ON-SITE SEWAGE DISPOSAL SYSTEM HOWARD COUNTY HEALTH DEPARTMENT BUREAU OF ENVIRONMENTAL HEALTH

Fyock's Septic Service, Inc. IS PERMITTED TO INSTALL ☒ ALTER ☐

SUBDIVISION: Friendship Manor LOT NUMBER: 22

ADDRESS: 2606 Wellworth Way PROPERTY OWNER: Robert Ashmore

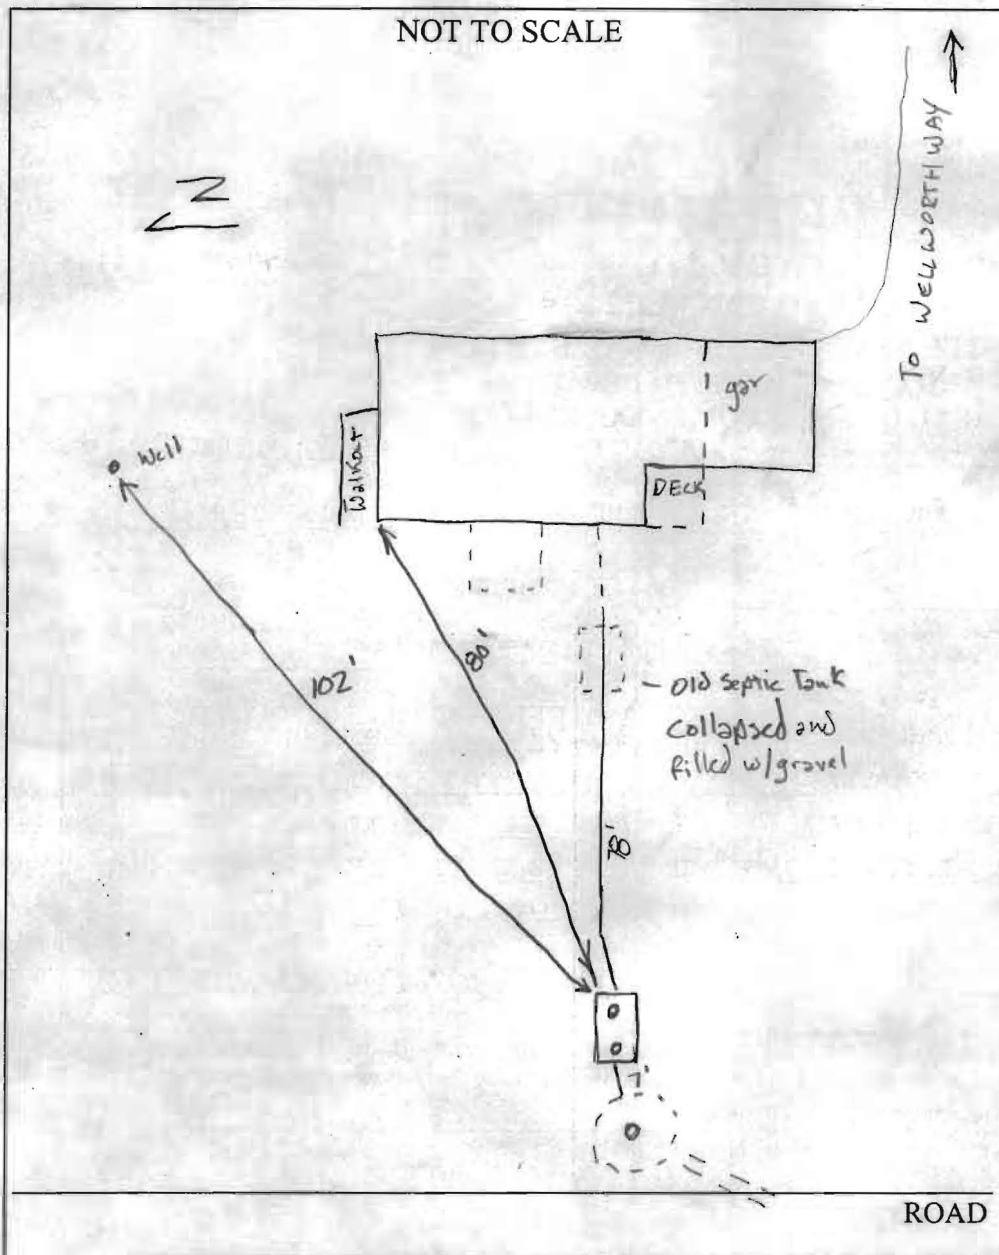
PRE-CONSTRUCTION 8/29/05 New Septic Tank, Keep away from (out of) well radius. GAC

INSTALLATION Septic Tank moved. New 1500 gal. 2 comp. septic tank placed outside 100' well radius and hooked up to existing dry well and trench which are near failure. Per Bob Weber. GAC Baffle Filter to be installed 8/30/05

TRENCHES:	Trench to be 2.0 feet wide. Inlet 3.0 feet below original grade. Bottom maximum depth 8.0 feet below original grade. Effective area begins at 4.0 feet below original grade. 5.0 feet of stone below distribution pipe.
LOCATION:	Keep the distribution box at the highest elevation.
NOTES:	Abandon drywell, pump and collapse old septic tank and place new septic tank outside of the well radius. Install 130' of trench in newly perced area. Avoid old trench from the drywell, maintain 10' away.
